Installation of an Engine Head Temperature Sensor

All Dynasys APU serial numbers from G1D13308 and lower

TSB-05282013-1 Rev 1 Page **3** of **3**

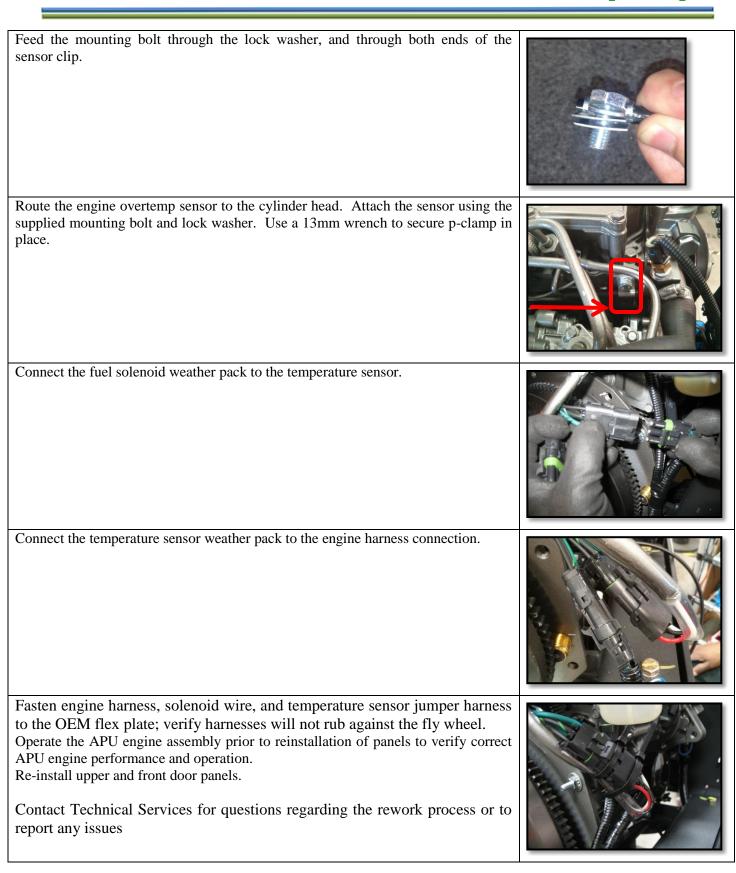
The previous APU design had limited redundancy in place to protect against engine overtemp situations. The addition of an engine block temperature switch should protect the engine in cases of extreme overheat. When the block reaches a designated temperature threshold, the switch will cut fuel to the engine and force the engine to shut down.

The addition of an over temperature switch jumper is designed to provide adequate system redundancy to protect the engine against overtemp events. The over temperature switch will open when the temperature sees 123C+/-3C. The switch jumper will be connected in between the main APU harness and fuel solenoid.

Instructions:	
Remove front APU engine door and upper cover panel assemblies. Locate the Fuel Hold Solenoid connector next to the fly wheel; cut the retaining zip tie from the OEM flex plate mounting hole. Disconnect the weather pack connections between the fuel hold solenoid and the engine harness.	
Locate the overtemp sensor jumper harness.	
Insert temp switch end into mounting clamp & close. Inspection and process notes: do not spread the clamp open as this may result in the temp sensor coming loose from the clamp.	
Feed the clamped block temp switch behind the OEM flex plate, under the fuel hold solenoid.
